Minutes of Pre-Bid Meeting

Subject: Minutes of Pre-Bid Meeting of “Maintenance and reconstruction of the collapsed compound wall of KINFRA Petrochemical Park Ambhalemugal Kochi.”

Tender No. - KINFRA/TCP/35/2024-25
Date of Pre-Bid Meeting - 07.01.2025, Tuesday at 10.30 a.m.
Location - KINFRA Petrochemical Park Site Office, Ambalamughal

Maintenance and reconstruction of Collapsed Compound Wall of KINFRA Petrochemical Park, Ambalamughal, Kochi

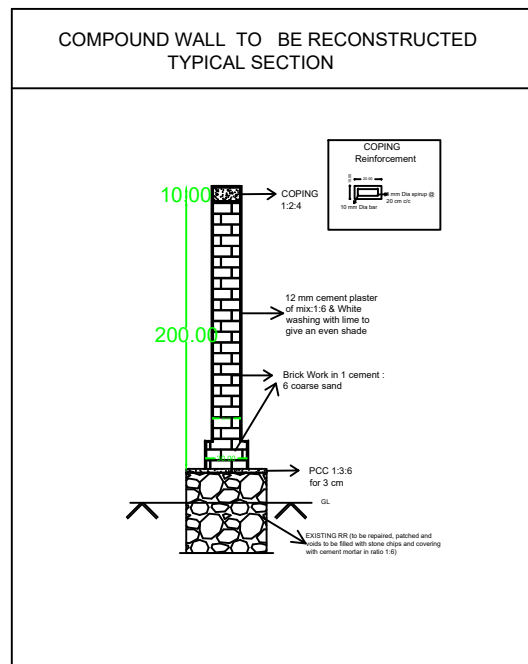
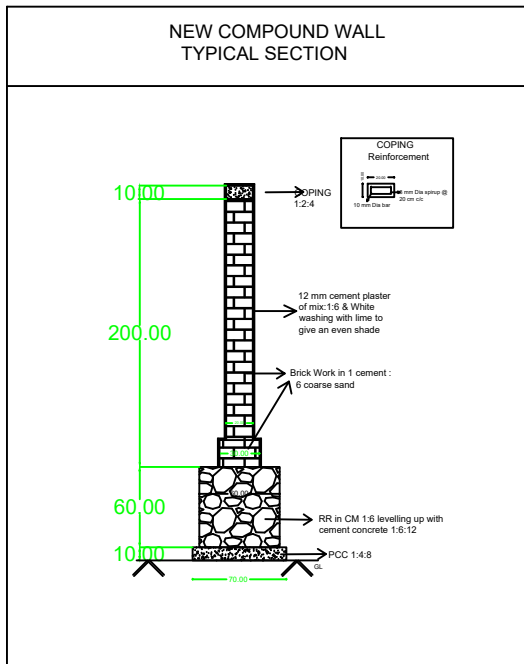
1. Mr. Shijan K. George inquired about the possibility of using a 15 cm brick in place of the 20 cm brick specified in item number 1.2. The Project Executive informed that the specifications as outlined in the Bill of Quantities (BOQ) cannot be altered and asked to follow the same.
2. For the construction of compound wall in the foundation existing areas, the existing foundation to be repaired, patched and the voids needs to be filled with stone chips and covered with cement Mortar in ratio 1:6 and above it 3 cm thick concrete mix in the ratio 1:3:6 needs to be provided. Above this the brick work needs to be commenced
3. Plinth beam need not be provided above the RR foundation
4. The typical cross section drawing for the compound wall that is to be newly constructed and to be reconstructed above the existing RR foundation shall be provided
